**Before the Hearings Panel
At Waimakariri District Council**

In the matter of the Proposed Waimakariri District Plan

Joint Witness Statement – DEXIN rezoning request (Urban Design)

**APPENDIX B - Urban Design Assessment, Proposed Pegasus Resort ODP, 1250
Main North Road, Ed Jolly, 05/07/2024**

APPENDIX A - Updated ODP

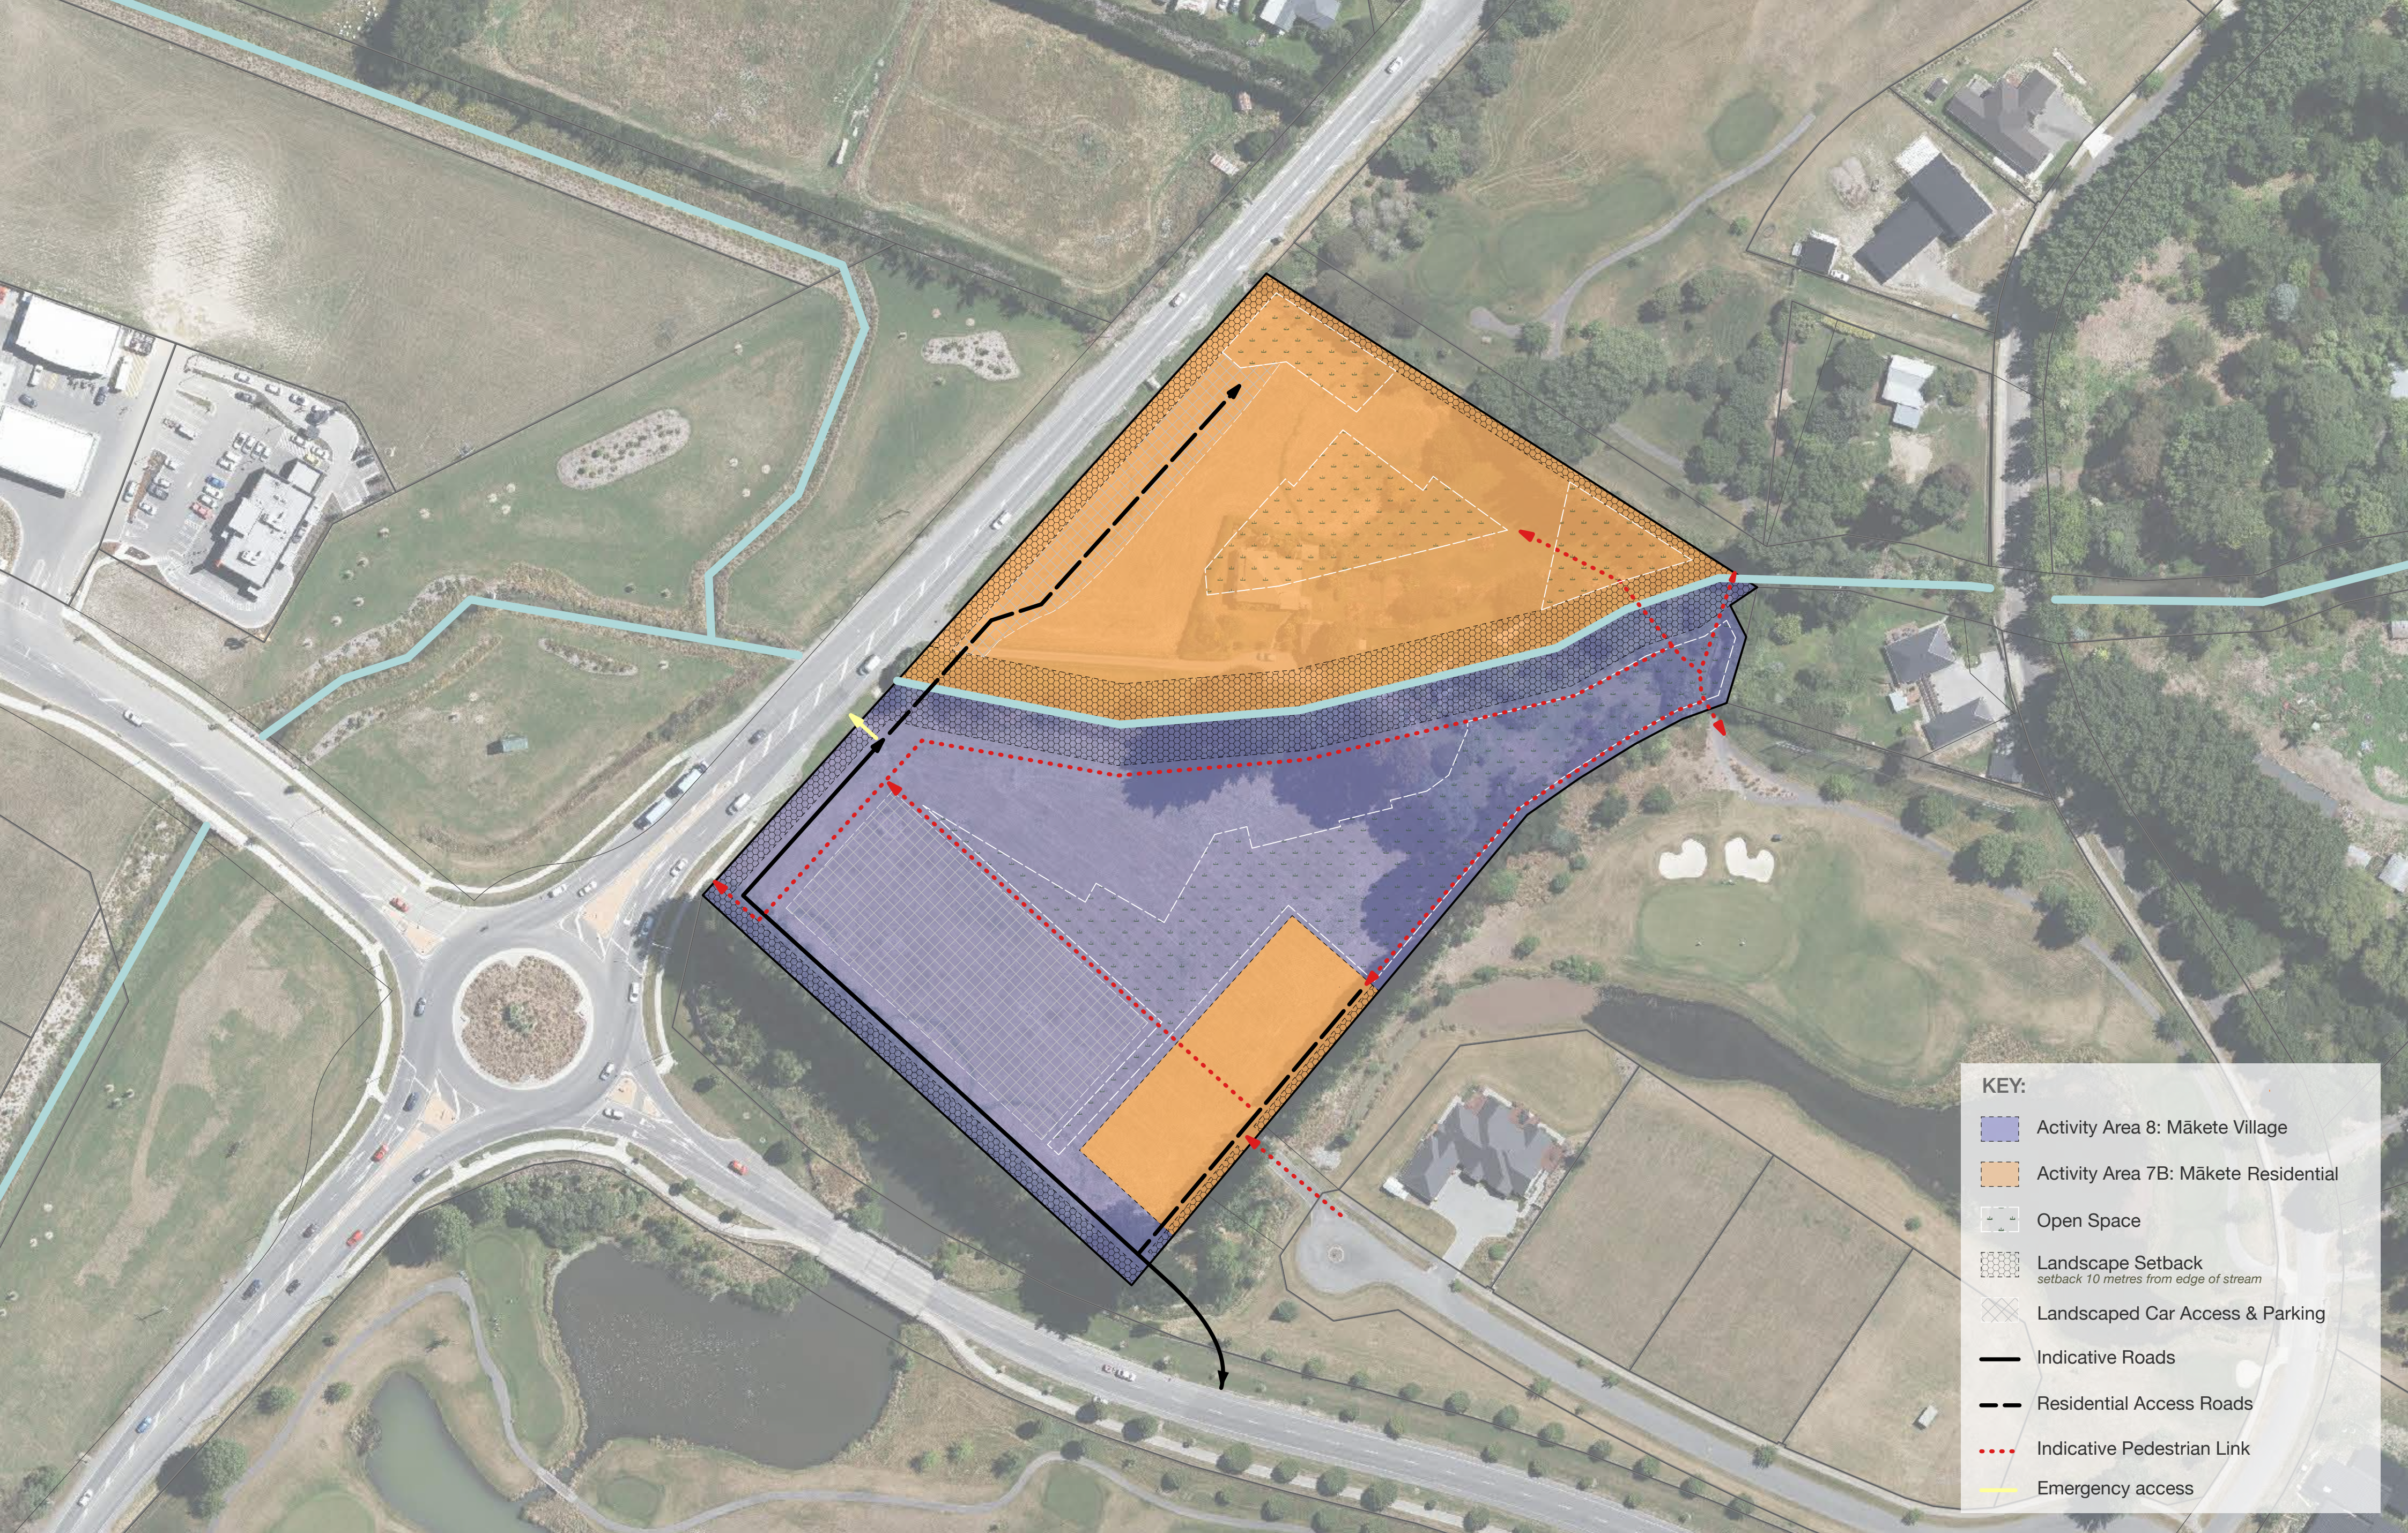
7 It was agreed that further detail was required in the ODP from an urban design perspective to give greater certainty of outcome and direction to future subdivision and consenting. The revised ODP tabled by the submitter DEXIN successfully meets the key areas of concern raised by the experts. This included the followings amendments to the ODP²:

- (a) Provision of communal open space within Activity Area 7B: Residential (Medium Density) to enable future residents with recreational, play and social opportunities.

- (b) Provision of stormwater / habitat creation /enhancement spaces adjacent to the Taranaki Stream within Activity Area 7B: Residential (Medium Density) to provide protection of the natural environment from development.

- (c) Provide the extent of vehicle access (streets) within Activity Area 7B: Residential (Medium Density) to enable street address for future dwellings and access for future residents.

- (d) Provision of open spaces within Activity Area 8: Māketete Village to enable high quality landscape outcomes to be achieved.
- (e) Provision of stormwater / habitat creation /enhancement spaces adjacent to the Taranaki Stream within Activity Area 8: Māketete Village to provide protection and enhancement of the natural environment from development.

- (f) Removal of vehicle access from Burntwood Lane cul-de-sac into Activity Area 8: Māketete Village to minimise movement effects on existing residents.

- (g) Provide pedestrian connections within Activity Area 8: Māketete Village to establish connectivity between the SH1 footpath and the Pegasus Resort.

(h) Provide the footprint of the carparking proposed within Activity Area 8: Māketete Village to establish its scale and location as well as the consequential default setback of built form which minimises the bulk and scale effects of future buildings from Pegasus Boulevard.

8 Experts believe that these amendments to the ODP will provide greater certainty and direction for future consenting. The experts have confidence that the likely urban design outcome will be positive from these changes.
